02.24.2014 RECOMMENDATION PACKAGE
3601 GREENWOOD AVE. N. | FREMONT GREEN | DPD PROJECT # 3015117

EDG DIRECTION		RESPONSE
<p>A-1 RESPONDING TO SITE CHARACTERISTICS</p> <p>THE SITING OF BUILDINGS SHOULD RESPOND TO SPECIFIC <i>SITE CONDITIONS AND OPPORTUNITIES SUCH AS NON-RECTANGULAR LOTS, LOCATION ON PROMINENT INTERSECTIONS, UNUSUAL TOPOGRAPHY, SIGNIFICANT VEGETATION AND VIEWS OR OTHER NATURAL FEATURES.</i></p> <p>EDG Report: The Board was particularly concerned about two relationships, that of the proposed structure to the townhouses to the north and that of the proposed amenity space to the outside courtyard of George & Dragon. In developing the design the applicants should take steps to enhance the compatibility of these physical and social relationships.</p>		<p>Response:</p> <p>The relationship between the proposed structure to the north townhouses is addressed in three-folds - reduced height, window placement, and provision of soft landscape along the property line.</p> <p>The north portion of the proposed structure is lowered 2ft, providing more direct sunlight to the townhouses than what was presented at EDG. See shadow studies in following pages p.28.</p> <p>Proposed struct

GREENWOOD AVENUE N.

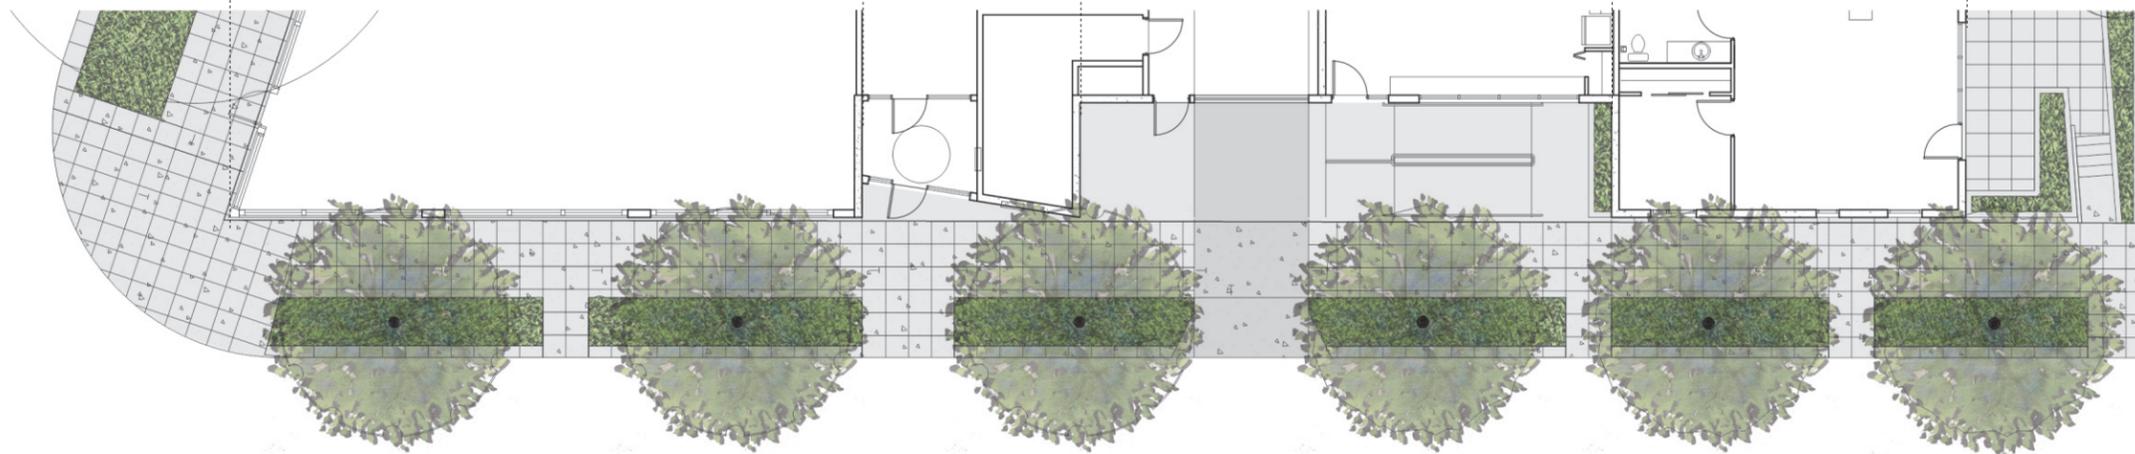
A-1, A-5, B-1, SHORTER PARAPET AND SMALLER MASSING TOWARDS RESIDENTIAL ZONE

A-10, C-3, MAXIMUM GLAZING AND CANOPY

C-3, D-12 GLAZING AND CANOPIES AT RESIDENTIAL ENTRY

D-6 DUMPSTERS AND UTILITIES NOT VISIBLE FROM THE STREET

A-1, A-5, B-1, D-2, D-3, E-3 SHORTER RETAINING WALL WITH LANDSCAPING

WEST PROPERTY LINE

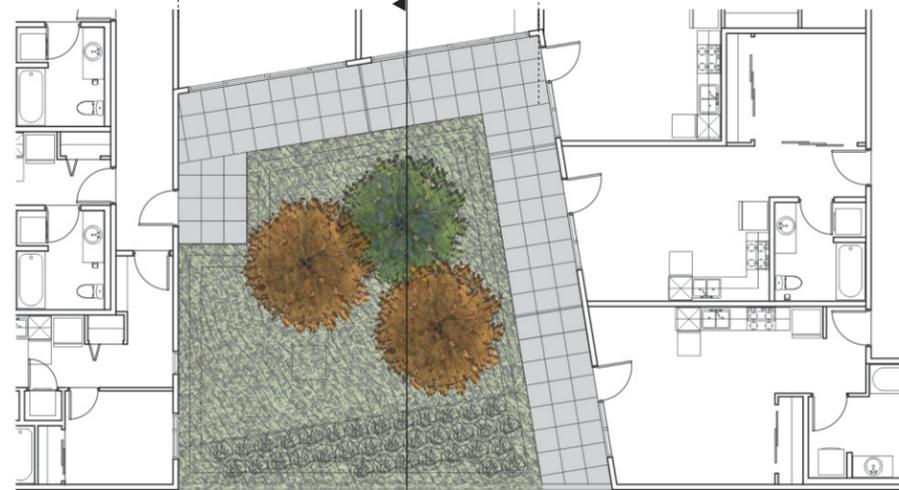
A-1, A-5, B-1, SHORTER PARAPET AND SMALLER MASSING TOWARDS RESIDENTIAL ZONE

A-1, A-5, B-1, D-2, D-3, E-3
WEST COURTYARD WITH RICH
LANDSCAPING FOR PRIVACY

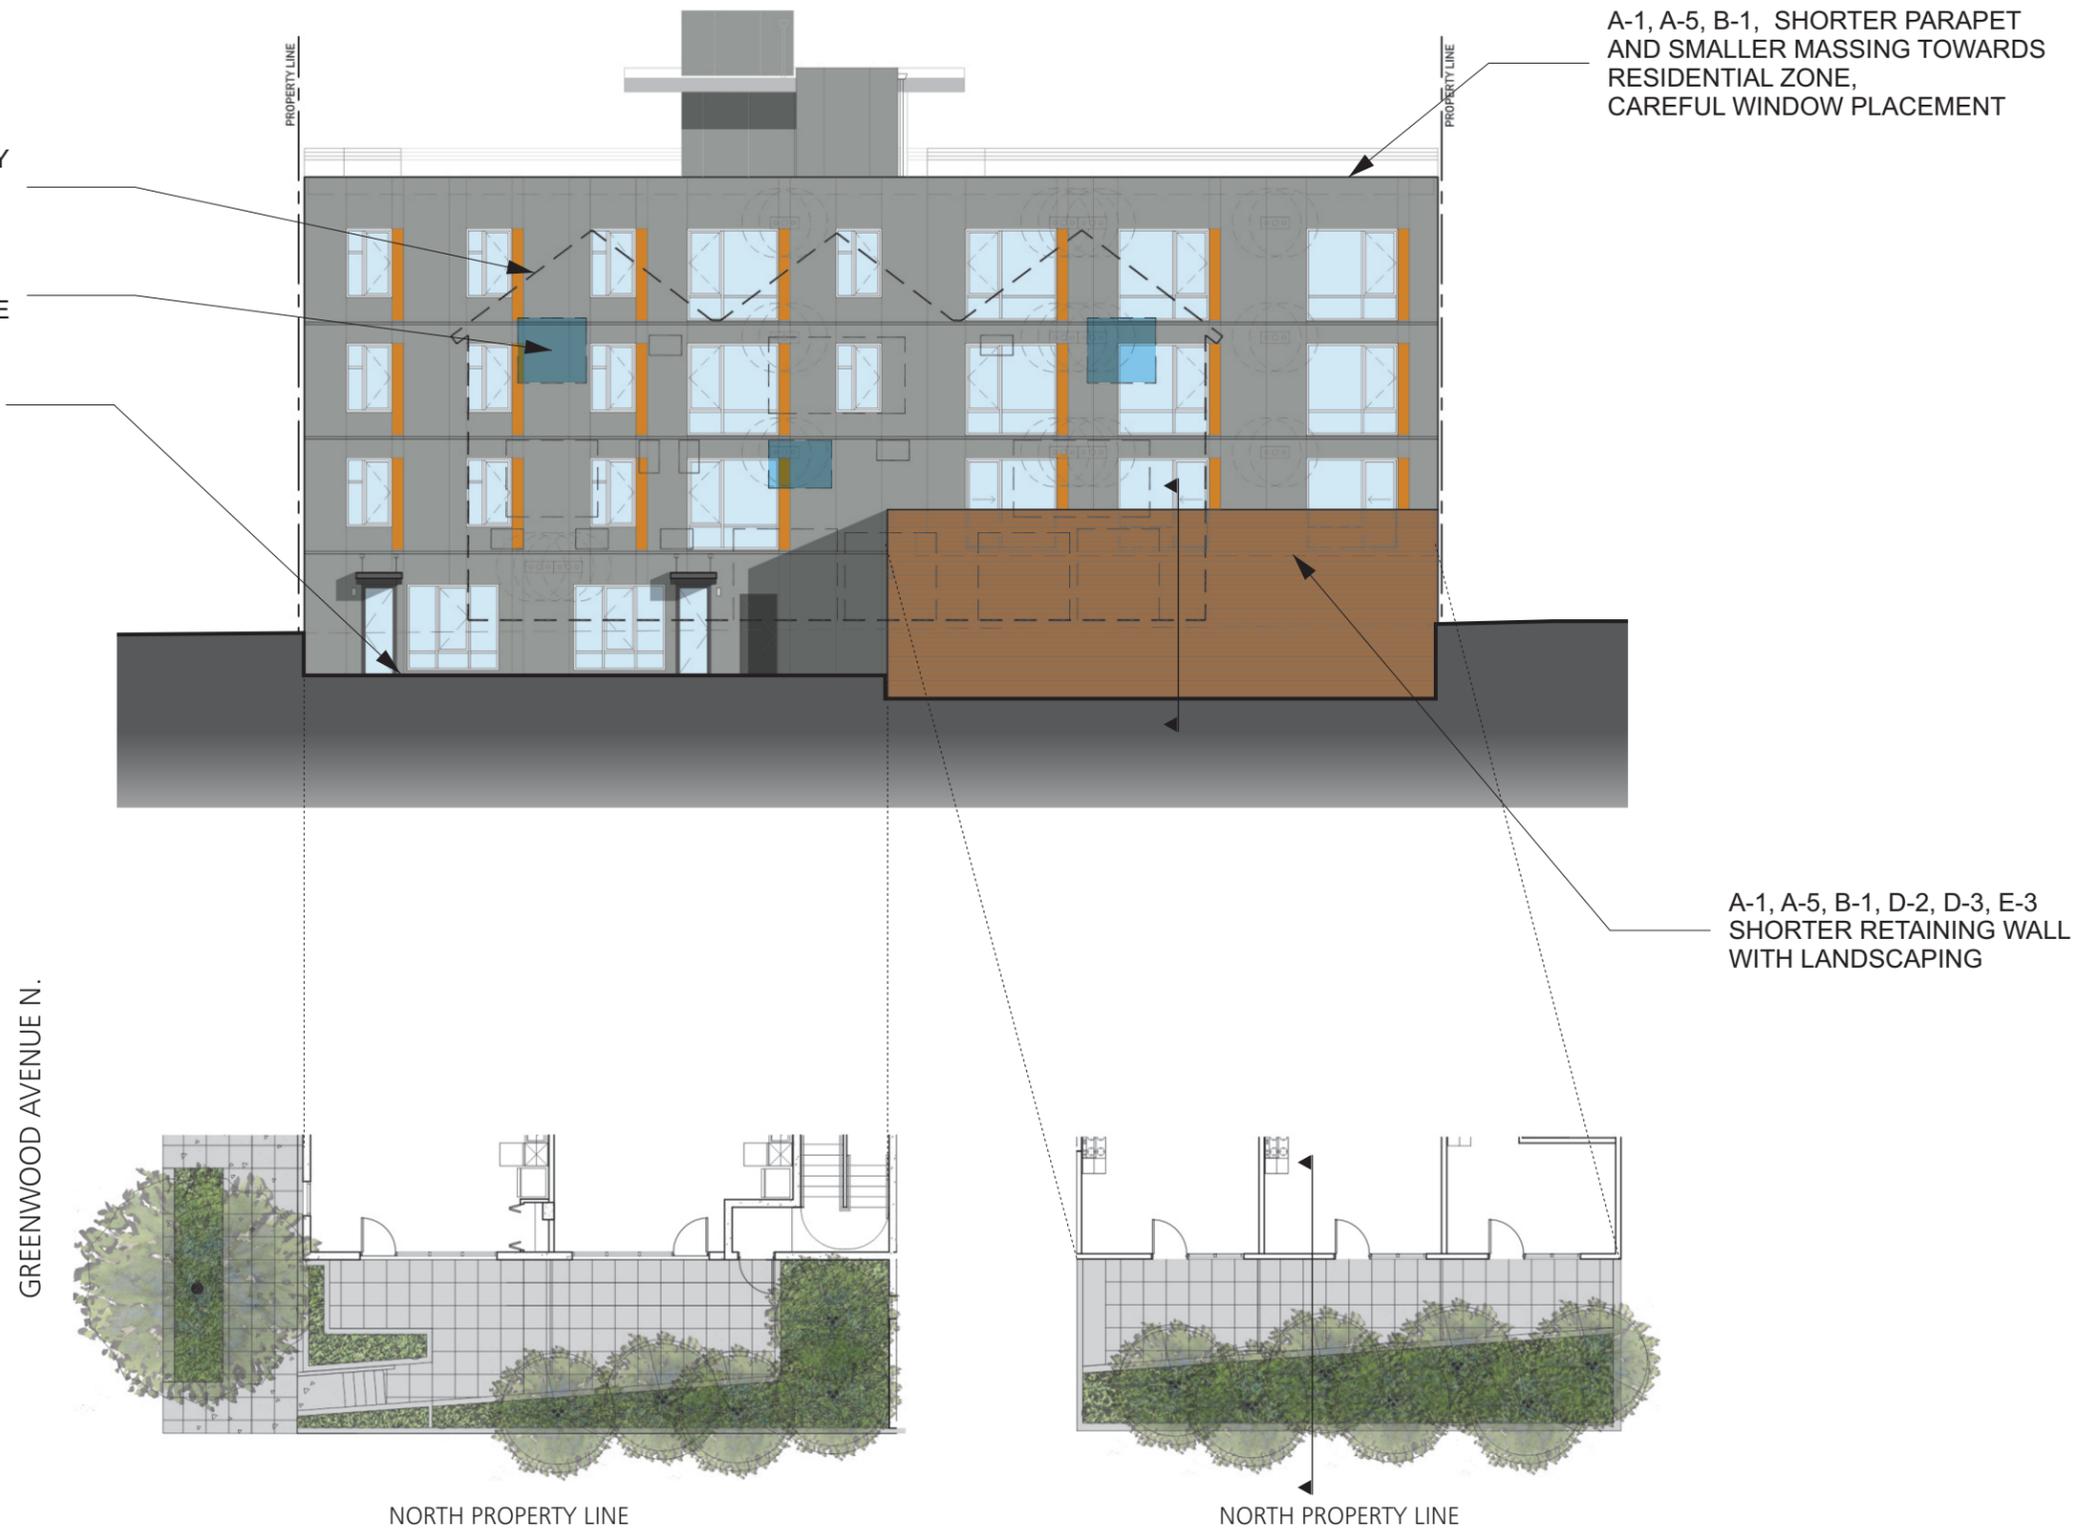
D-12 RESIDENTIAL TRANSITION
DEPARTURE REQUESTED

A-1, A-5, B-1, SHORTER PARAPET
AND SMALLER MASSING TOWARDS
RESIDENTIAL ZONE,
CAREFUL WINDOW PLACEMENT

SECTION LOOKING NORTH

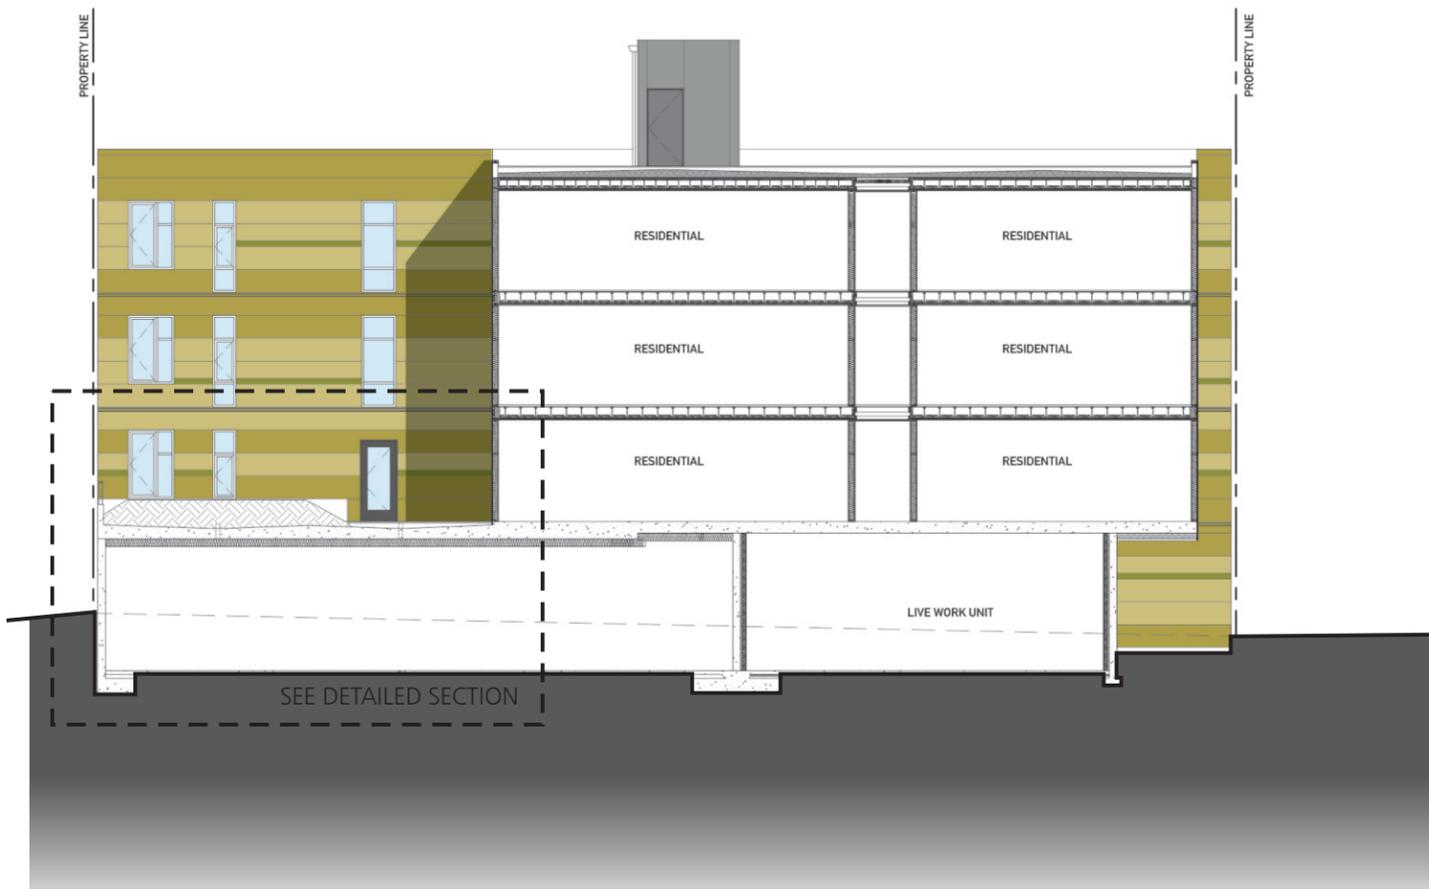
A-1, A-5, B-1, D-2, D-3, E-3
SHORTER RETAINING WALL
WITH LANDSCAPING
